RECALL BULLETIN 09V-337

DATE: October 5, 2009
MODEL YEAR: 2007 & 2008
CHASSIS MODEL: UD3300 with Locally Installed DUAL STEERING
BULLETIN NUMBER: 09V-337

VOLUNTARY SAFETY RECALL CAMPAIGN NUMBER 09V-337 STEERING STOP ADJUSTMENT

Figure B

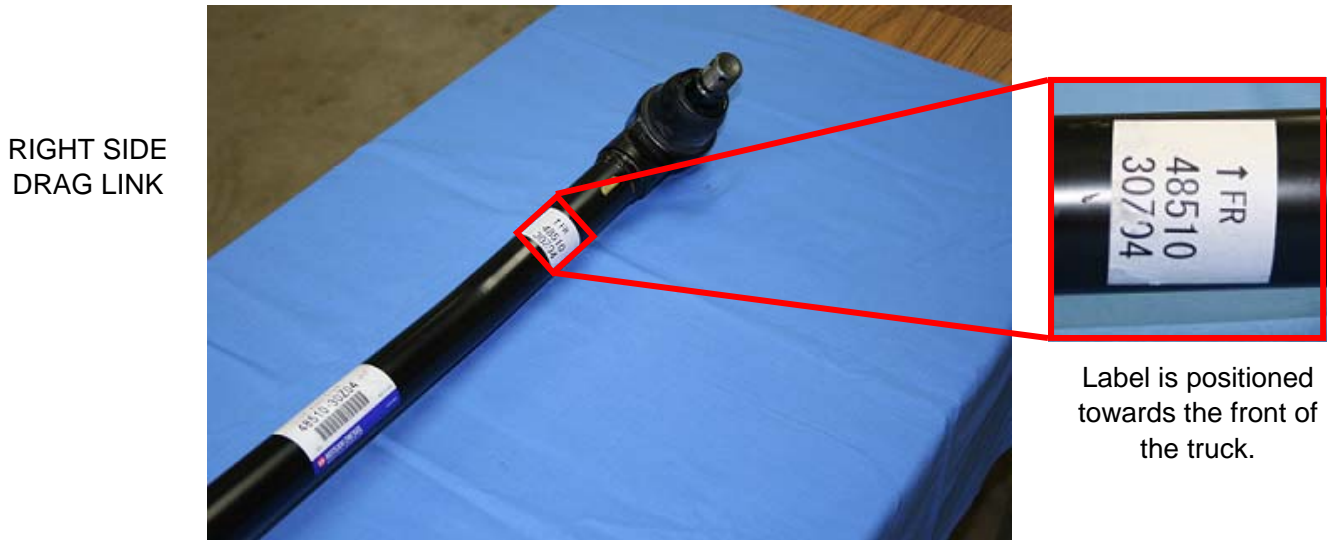
- A) The drag link should be installed with the directional arrow and part number label facing the front of the truck. The label may be covered with road dirt and the arrow not visible. The drag link is installed correctly if the label is positioned towards the front of the truck and steering gear. See figure B.

- B) If the drag link is installed correctly proceed to step 2.
- C) If the drag link is installed incorrectly remove the drag link and reinstall in the correct direction as shown in Figure B. Torque the nuts to 159 -253 lb.ft. and install the cotter keys.
- D) If the drag link has been damaged by contact with the tire, install a new drag link part number **4851030Z04**.
- E) Install the new drag link with the directional arrow facing the front of the truck. Torque the drag link nuts 159 -253 lb.ft. and install the cotter keys.

Figure C

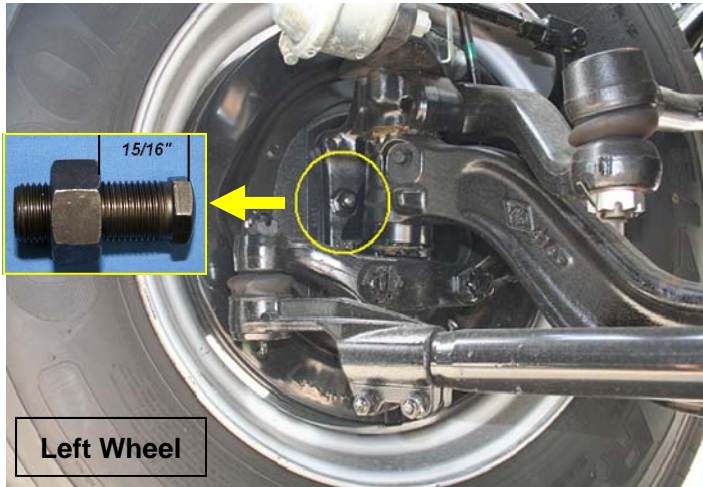
A) LEFT SIDE STEERING STOP ADJUSTMENT

- 1) Adjust the steering stop bolt to protrude 15/16 inch from the top of the jamb nut to the top of the stop bolt hex. See Figure C insert.
- 2) Start the engine. The engine must be running and the tires on the ground to verify correct tire to drag link clearance.
- 3) Sitting in the **RIGHT** side drivers seat turn the steering wheel all the way to the **LEFT** and verify that there is a minimum of 1½ inch clearance from the inside of right front tire to the drag link as shown in Figure D.
IMPORTANT: You must use the **RIGHT** side steering position to verify the minimum clearance of 1½ inch.
- 4) If the clearance is not 1½ inch adjust the stop bolt out further until the required 1½ inch clearance is achieved.
- 5) Torque the steering stop jamb nut to 101-123 lb.ft.

Figure E

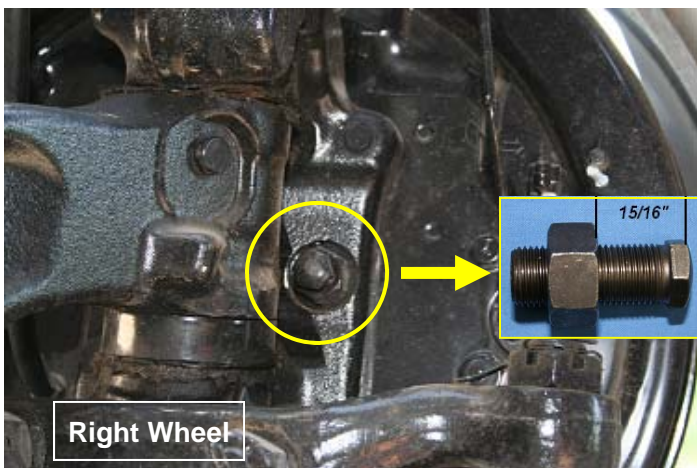
B) RIGHT SIDE STEERING STOP ADJUSTMENT

- 1) Adjust the steering stop bolt to protrude 15/16 inch from the top of the jamb nut to the top of the stop bolt hex. See Figure E insert.
- 2) Start the engine. The engine must be running and the tires on the ground to verify correct tire to drag link clearance.
- 3) Sitting in the **LEFT** side drivers seat turn the steering wheel all the way to the **RIGHT** and verify that there is a minimum of 1½ inch clearance from the inside of the **LEFT** front tire to the drag link. See Figure F.
IMPORTANT: You must use the **LEFT** side steering position to verify the minimum clearance of 1½ inch.
- 4) If the clearance is not 1½ inch adjust the stop bolt out further until the required 1½ inch clearance is achieved.
- 5) Torque the steering stop jamb nut to 101-123 lb.ft.
